WELL TEST ANALYSIS

Project: 7245 & 7433

Location: Grant County

Data Set: C:\Users\trevora\Documents\2023\_moves\7245\_7433\7245 & 7433 Current.aqt

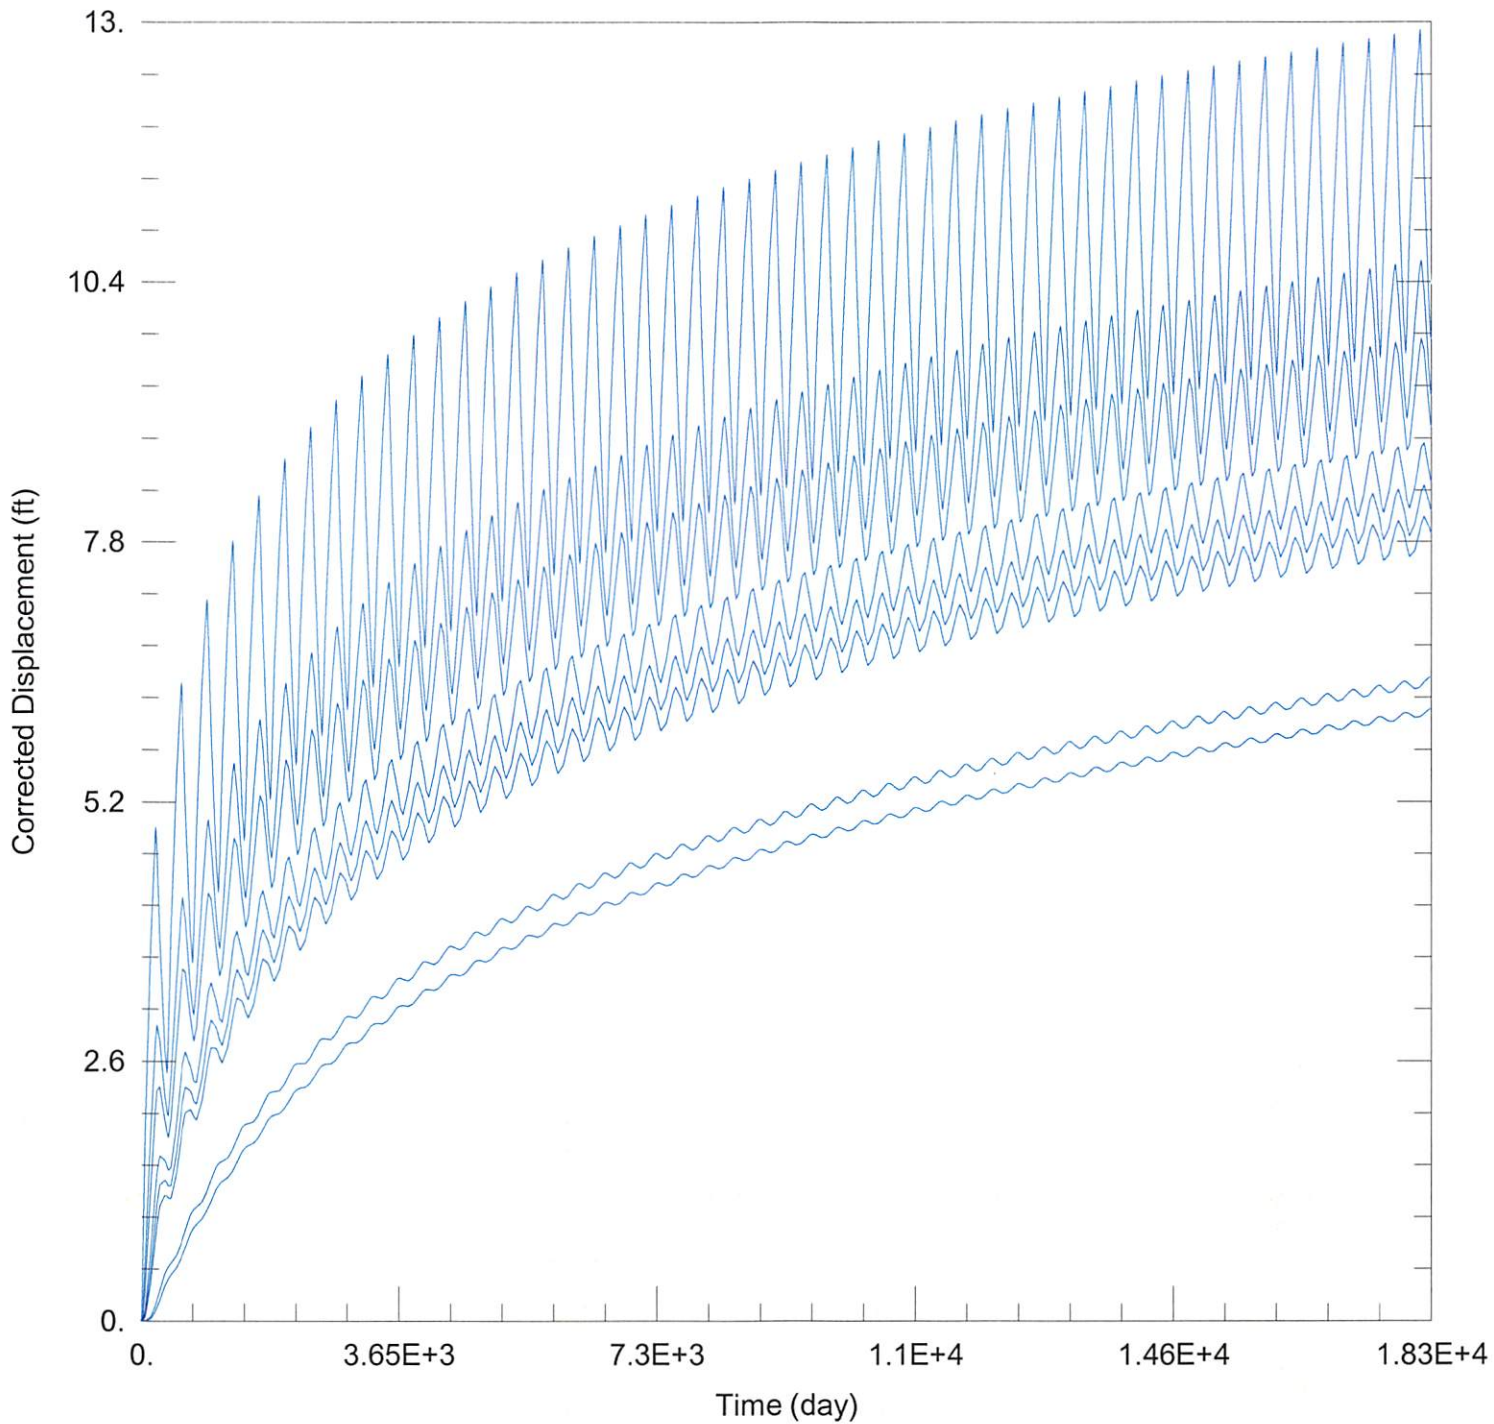
**7433:**

Water Column = 40 ft

DP = 3.3 ft (Net drawdown from the proposal indicated above)

DE = 7.5 ft (Water level decline from 2023 through 2048 based upon GMD3 model)

DD = 35.4 ft (S = 0.2086, T = 1335.5 ft<sup>2</sup>/day, Q = 150 gpm, tp = 130 days, efficiency = 70%)

DT = 46.2 ft

Total drawdown is greater than the remaining saturated thickness, so this well is **critical**.

Data Set: C:\Users\trevora\Documents\2023\_moves\7245\_7433\7245 & 7433 Proposed.aqt  
 Date: 04/04/23 Time: 15:58:23

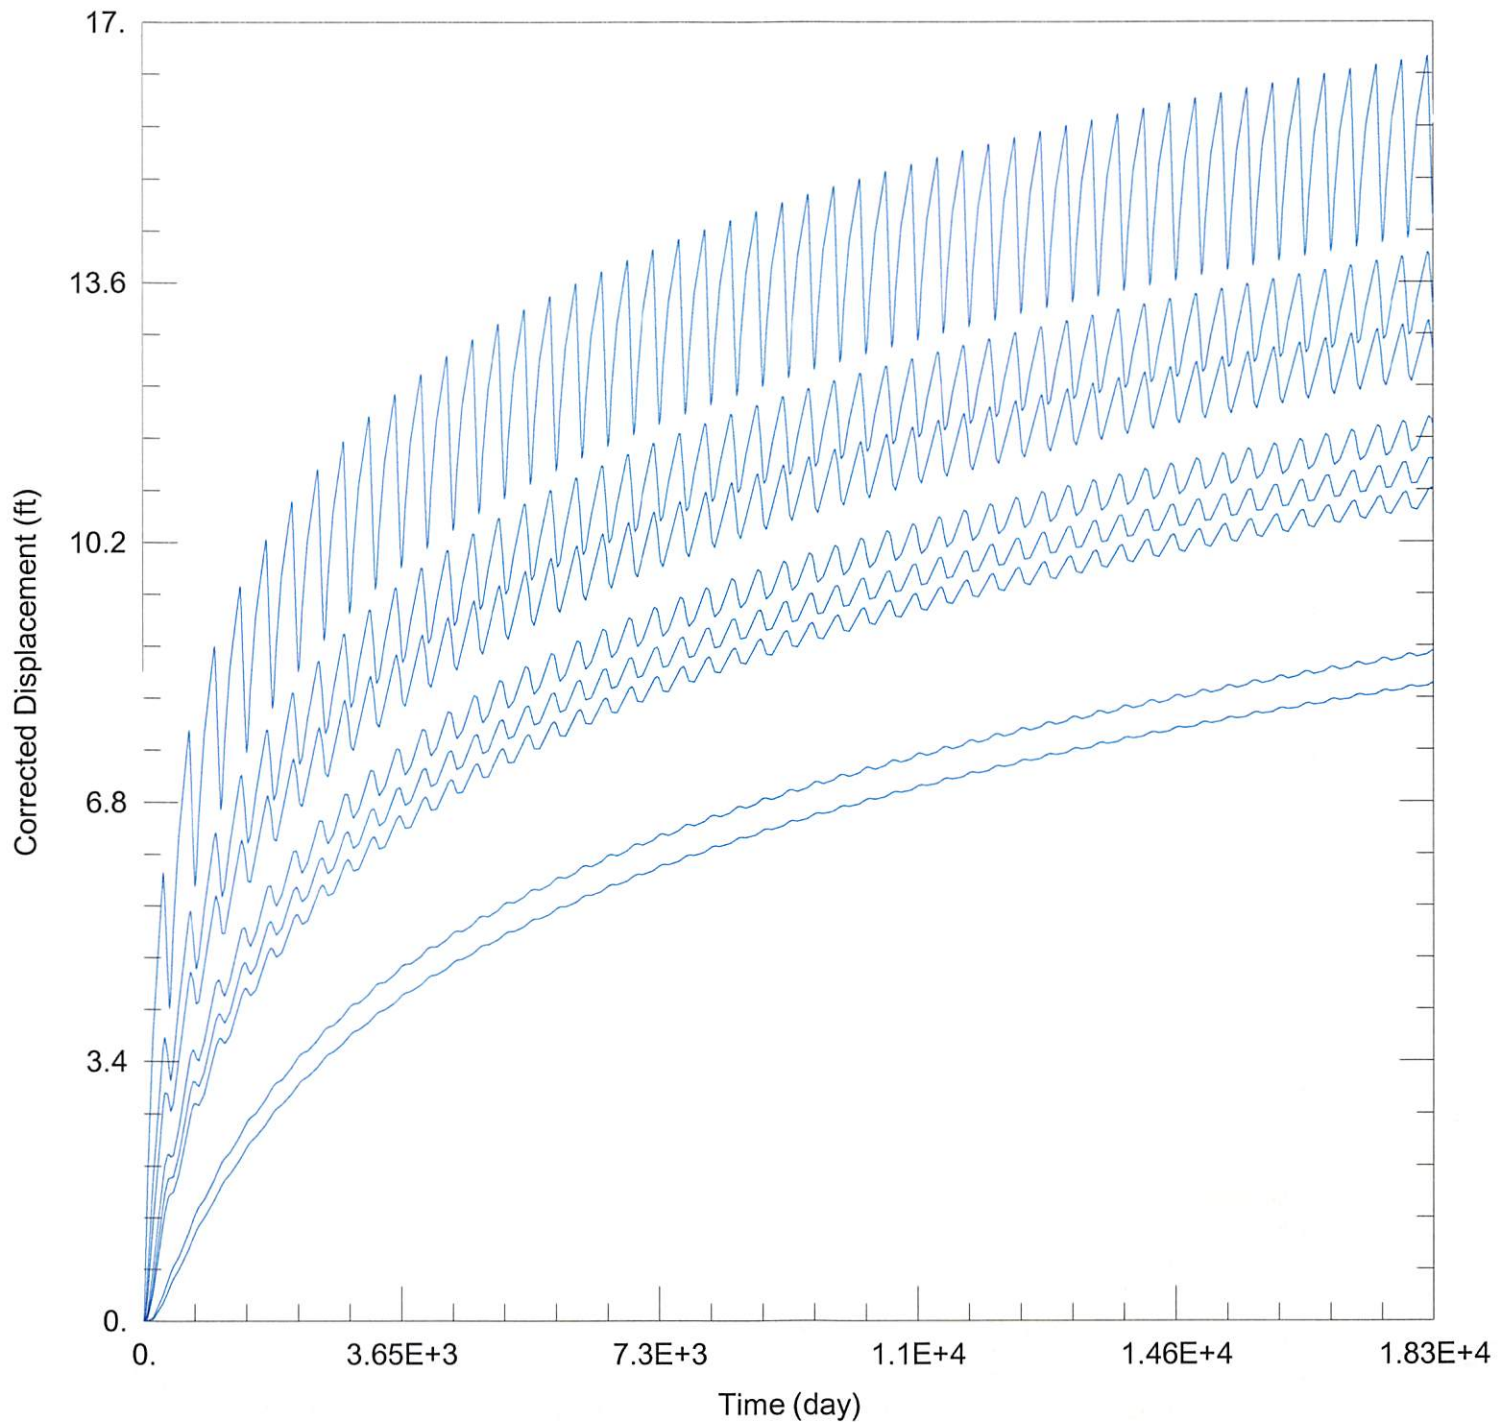
7433: Drawdown from current location = 9.83 ft  
Drawdown from proposed location = 13.09 ft  
Net drawdown = **3.3 ft**
